## Reviewer 1

*This paper assesses the impact of accounting for irrigation when calculating root zone storage based on a wealth of large hydroclimatic datasets applied to numerous catchments across the globe. The authors evidence a general reduction of root zone storage estimates, more marked in absolute value in locations with more than 10% of irrigated area (17-22mm reduction) or in a humid tropical climate, while the relative reduction is largest in temperate locations (16-22% reduction).*

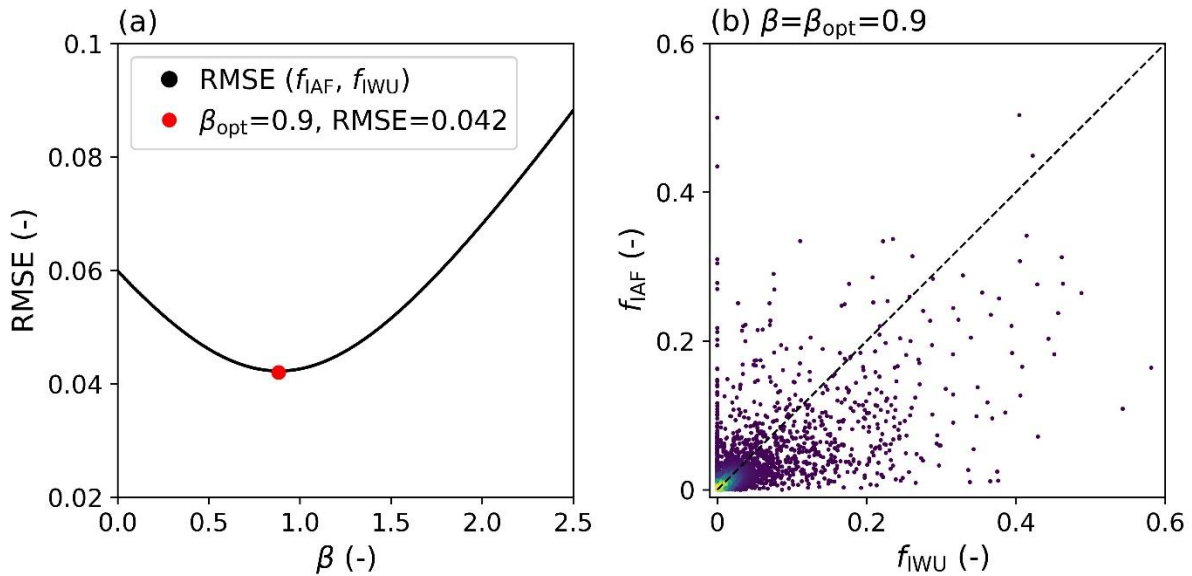
*L160-164 / Fig. 3: since the  $RMSE(f_{IAF}, f_{IWU})$  is computed for all catchments (for each beta value), why not showing the spread of RMSE (e.g. interquartile range) instead of a single line? Can you justify with beta should be constant for all catchments? i.e., why not computing 4511 catchment-specific beta values that minimize the RMSE, as I doubt it is strictly 0.9 everywhere? Could the authors clarify this point, as the potential impact of this variability (or computing choice) upon  $S_r$  estimates in the IAF case could be quite interesting to discuss.*

In the IAF method we use a constant value for beta, that is derived from the irrigation water use data in combination with the irrigated area data. Beta was chosen as a constant to create a relatively simple approach that does not directly rely on the irrigation water use data, which is beneficial for application in time periods without irrigation water use data (both historical and future), as well as for regions where no reliable irrigation water use data is available. Moreover, using 4511 catchment-specific beta-values would in principle be the same as the IWU method, as beta is derived from the irrigation water use data. Figure 3 shows the RMSE for each beta value, and the line is a combination of many points. For each beta we have 4511 deviations between  $f_{IAF}$  and  $f_{IWU}$ , and combining these deviations gives the RMSE for that specific beta. To clarify this approach, and to show the spread of the results, we will add another panel to the figure with the catchment specific  $f_{IAF}$  and  $f_{IWU}$  values for the optimal beta value of 0.9 (see Fig. C1).

To clarify the choice of a constant beta, we will modify L160-164 as follows:

*“with  $I_a$  (-) the catchment irrigated area fraction and  $\beta$  (-) a correction factor that is constant in space and time for all catchments.  **$\beta$  was chosen as a constant to create a relatively simple approach that***

does not directly rely on irrigation water use data, which is beneficial for application in time periods (both historical and future), without irrigation water use data, as well as for regions where no reliable irrigation water use data is available. We estimated  $\beta$  by minimizing the difference between  $f_{IAF}$  and  $f_{IWU}$  in terms of Root Mean Squared Error (RMSE). We generated 1000 linearly spaced values for  $\beta$  between 0 and 2.5, and computed  $f_{IAF}$  for all the catchments. For all these cases, the RMSE of catchment  $f_{IAF}$  and  $f_{IWU}$  was computed (Fig. 3). The RMSE minimized for  $\beta = 0.9$  (RMSE = 0.042), which is applied for all catchments in Eq. (6).”

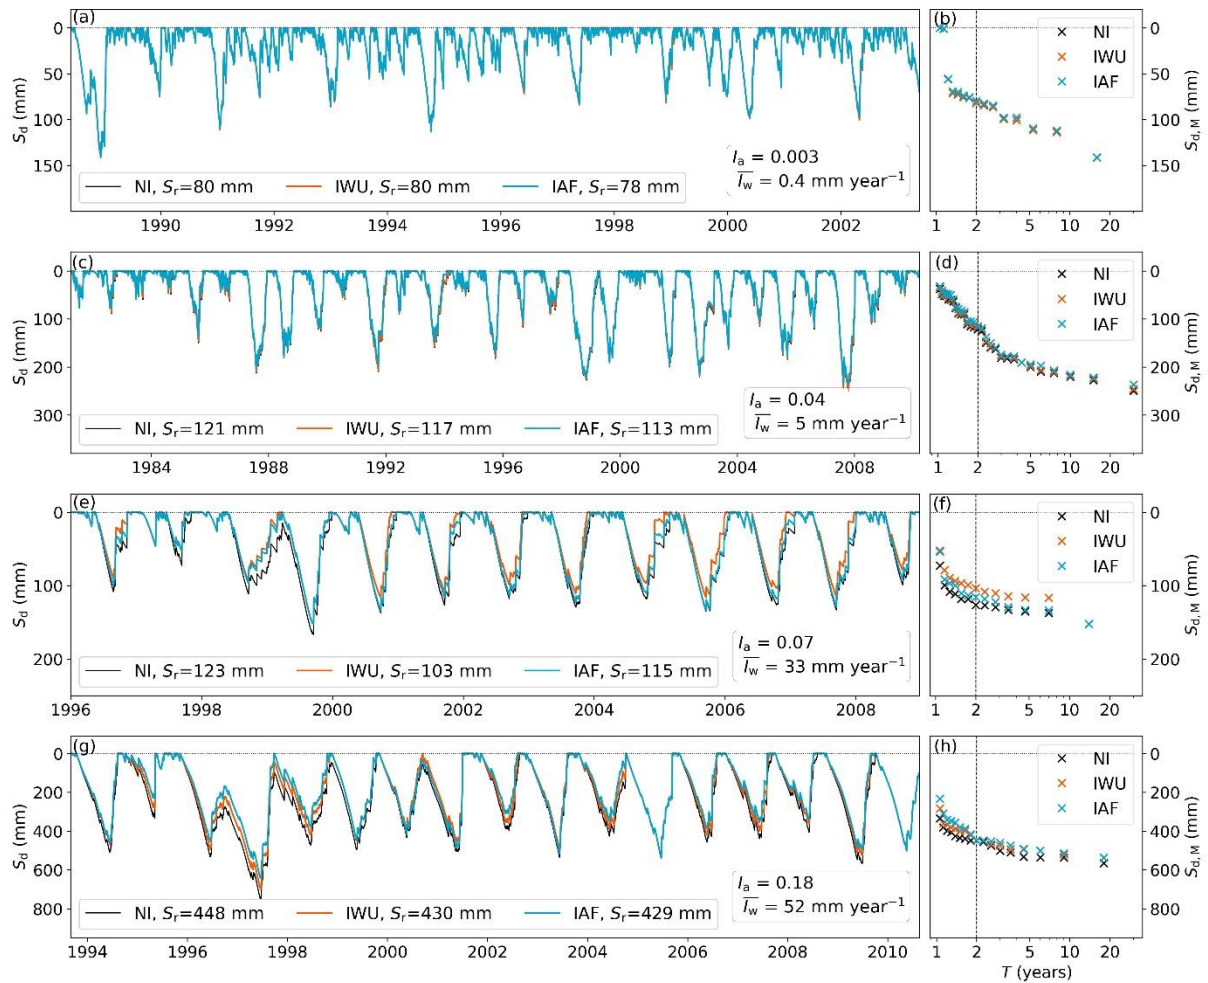
**L169-179:** I had to read this section several times to understand how  $S_r$  was finally derived, and I am not sure I did. It is announced in the first sentence but referring to a Table 1 which is actually more a reminder list of notations than explaining  $S_r$ . In the last sentence it is said that it is the mean of three values, while  $S_r$  is separately computed for NI, IWU, and IAF right? What is meant by “ $S_{d,M}$ -values with occurrences closest to  $T = 2$  years”? Perhaps a supplementary figure with an example of  $S_r$  calculation across return periods for a (given set of) catchment(s) would help.

We compute the  $S_r$  separately for NI, IWU, and IAF. For each case,  $S_r$  is computed as the average of the three annual maximum  $S_{d,M}$  ( $S_{d,M}$ ) values with occurrences closest to  $T=2$  years (return levels of  $S_{d,M}$  are presented by the crosses in Fig. 5b,d,f and h). To clarify the  $S_r$  calculation we modified L176-179 as follows:

“Here, we directly used the observed  $S_{d,M}$  -values with occurrences closest to  $T=2$  years instead of a fitted extreme value distribution, because fitting an extreme value distribution is ambiguous for return periods of interest (here: 2 years) much smaller than the timeseries length (here: >10 years). For all catchments, **for each irrigation case separately**, the  $S_r$  was estimated as the mean of the three observed  $S_{d,M}$  -values with occurrences closest to  $T=2$  years, **as represented by the cross-markers closest to the vertical dashed line at  $T=2$  years in Fig. 5b, d, f, and h.**”

We clarified this issue in Fig. 5 (see Fig. C2 below) by changing the x-axis labels, by the dots in (b), (d), (f) and (h).

Figure C3. Relative difference in  $S_r$  ( $\Delta_r S_r (-)$ ) for IWU compared to IAF  $((IWU-IAF)/IAF)$ . See Table 1 for details on the irrigation cases.

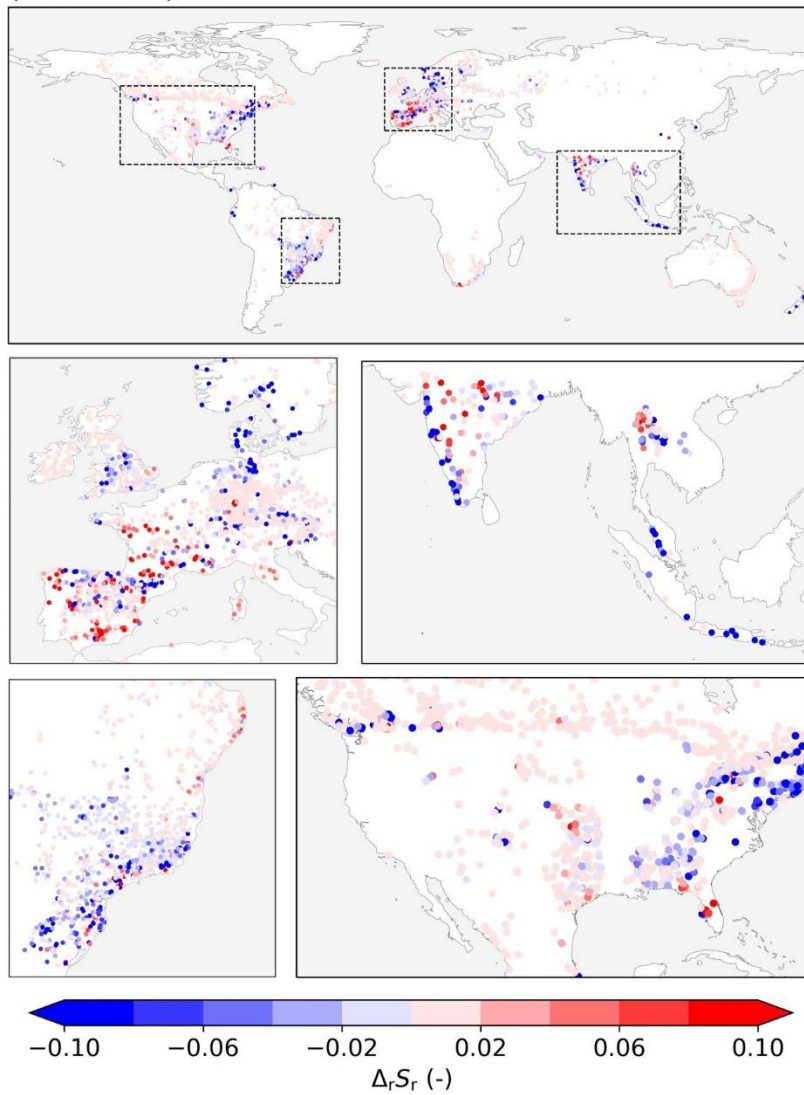
**L224-232:** For this discussion, consider adding a third panel to Fig. 6 with the relative difference between IWU and IAF, to look for patterns?

For completeness of the results, we will include the relative differences between IWU and IAF in the supplementary information of the manuscript (See Fig. C3), and refer to it in the text.

We will modify L224-225 as follows:

**“Figure 6 shows similar spatial patterns of  $\Delta_r S_r$  for IWU and IAF, but the magnitudes differed. For most groups of catchments, IAF had a more pronounced effect on  $S_r$  than IWU (Table 2, **Fig. S4**).”**

Figure C1. Catchment  $S_r$  for the No Irrigation (NI) case, with dots representing catchment outlets. Similar figures for the IWU and IAF cases are presented in Fig. S1.

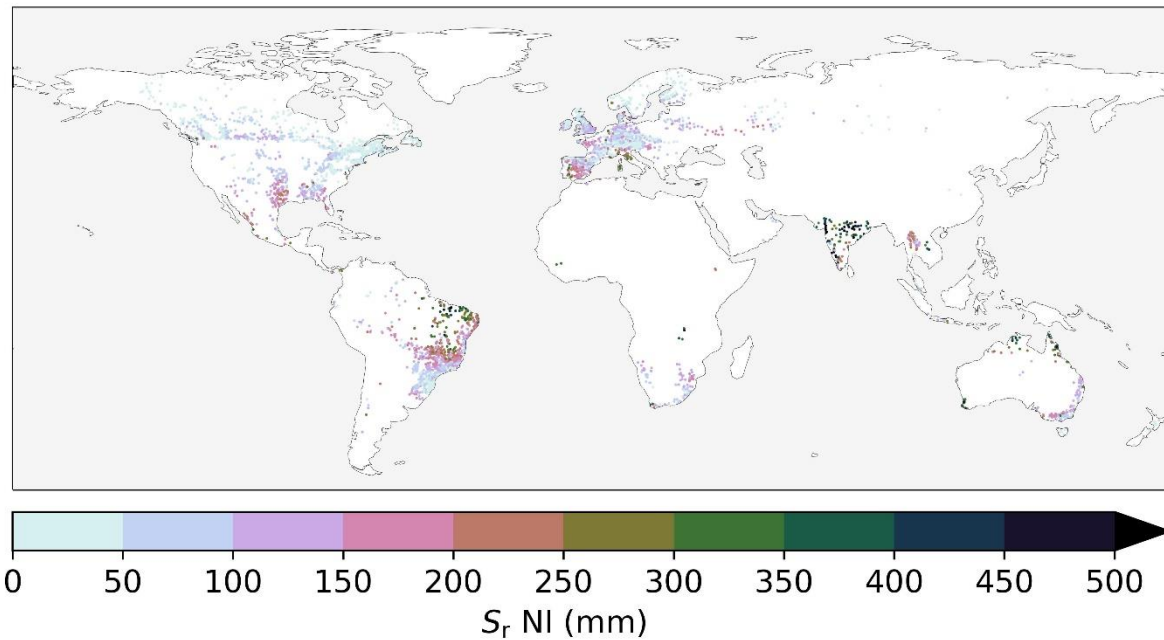
*Fig. 4 and 6: the way the figure is plotted in the preprint this is very hard to read given the size and color palette.*

For Fig. 4 we will change the colormap to the matplotlib ‘cubehelix’ colormap, which is colorblind-proof, and covers a relatively large lightness-range. See the updated figure in Fig. C1.

For Fig. 6, we believe that the here used colormap represents our intentions with the figure well, as we want to emphasize on the catchments where the  $\Delta S_r$  is relatively large (the darker, the larger), while still showing the catchments with small  $\Delta S_r$  (yellow).
